Access Compliance Report

Public Rights-of-Way

Intersection ID: 10026441	Main Street: FARMHURST_DR	Cross Street: N/A	Location: NW
ADA ID: 611EAC18E5E4	Ramp Type: PerpDiag	Initial Pass/Fail: Fail	Overall Compliance: No
		Severity Score: 35

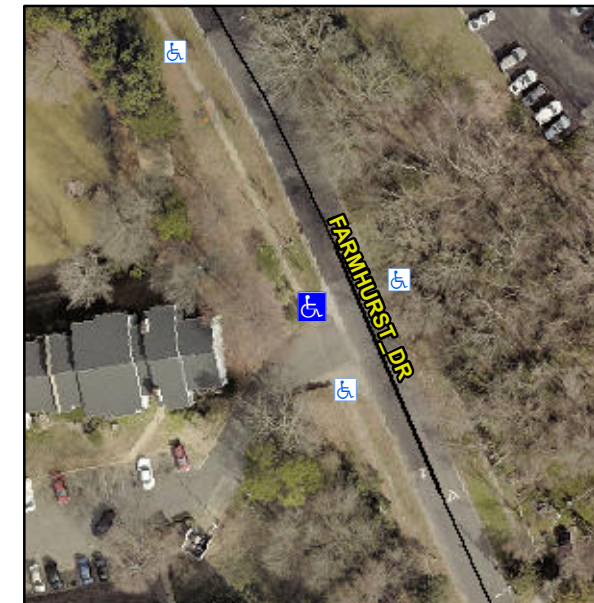
Not Found, R304.5.1, R304.2.2, R304.5.3

Compliance	Description	Data	Compliance	Description	Data
N/A	Ramp Length (in)	32.0	No	Ramp Slope (%)	14.9
No	Ramp Width (in)	37.0	No	Ramp XSlope (%)	2.3
N/A	Flare Type LT	N/A	N/A	Flare Type RT	N/A
N/A	Flare Slope LT (%)	N/A	N/A	Flare Slope RT (%)	N/A
N/A	Flare Traversable LT?	N/A	N/A	Flare Traversable RT?	N/A
N/A	Landing Length (in)	N/A	N/A	DWS Provided?	N/A
N/A	Landing Width (in)	N/A	N/A	DWS Contrast?	N/A
N/A	Landing Slope (%)	N/A	N/A	DWS Length (in)	N/A
N/A	Landing X Slope (%)	N/A	N/A	DWS Full Width?	N/A
N/A	Landing Curb? (Y/N)	N/A	N/A	DWS Offset (in)	N/A
N/A	Shared Landing?	N/A			
N/A	Gutter Ponding?	N/A	N/A	Gutter Slope (%)	N/A
N/A	Gutter Lip Ht (in)	N/A	N/A	Gutter X Slope (%)	N/A
N/A	Painted X Walk1?	No	N/A	Painted X Walk2?	No
	X Walk 1 Direction	To S		X Walk 2 Direction	To E
N/A	X Walk 1 Width (in)	N/A	N/A	X Walk 2 Width (in)	N/A
	X Walk 1 Slope (%)	1.9		X Walk 2 Slope (%)	8.5
	X Walk 1 X Slope (%)	5.2		X Walk 2 X Slope (%)	6.1

Remove & Replace Curb Ramp With Two New Directional Ramps or Equivalent.
